INVITATION FOR BID

CONSTRUCT EXIT TAXIWAYS B9 AND B15

ADDENDUM # 1

SCOTTSDALE AIRPORT
CONSTRUCT EXIT TAXIWAYS B2, B9 AND B15
15000 N AIRPORT DRIVE
SCOTTSDALE, ARIZONA, 85260

E-603

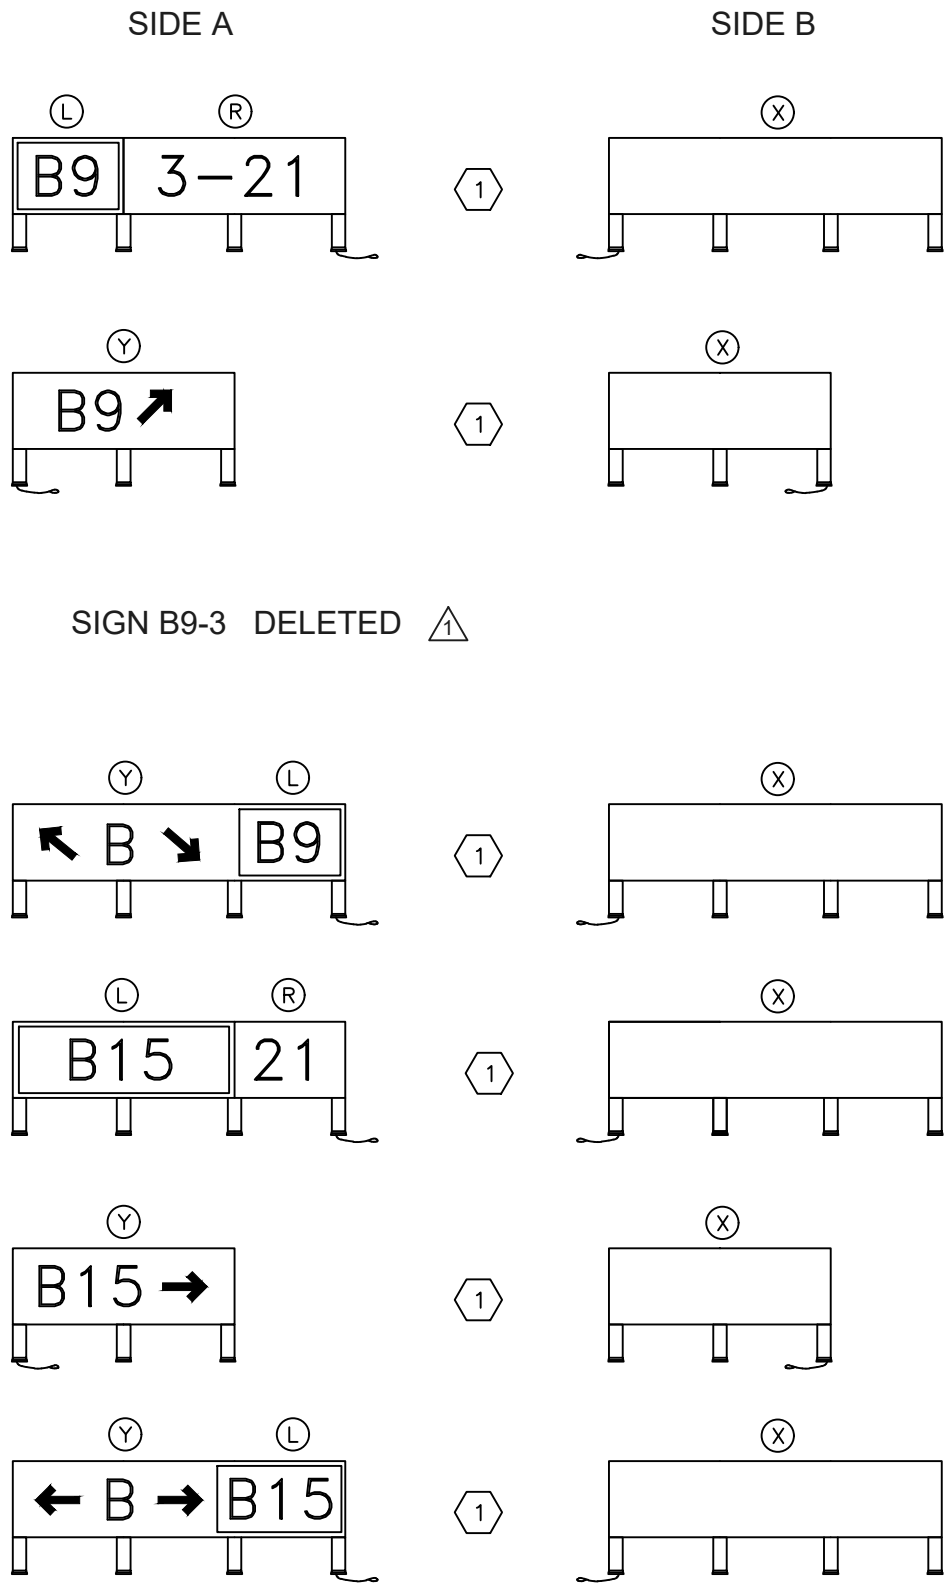
- Plan Sheet E-603 within the original IFB is replaced with the attached revised E-603 page. Sign B9-3 has been removed from the revised E-603.

Q1. Both bid schedules A and B have three new total signs. However, there is a total of seven new signs on the sign schedule (E-603). Sign B9-3 appears to be an orphan. It is on the sign schedule but does not appear on the electrical layout plans (E-201, E-202). Does B9-3 have a place in the project?

A1. See the attached plan sheet which revises the sign schedule shown on sheet E-603. The sign in question (Sign B9-3) is not part of the project and has been removed from the attached sheet.
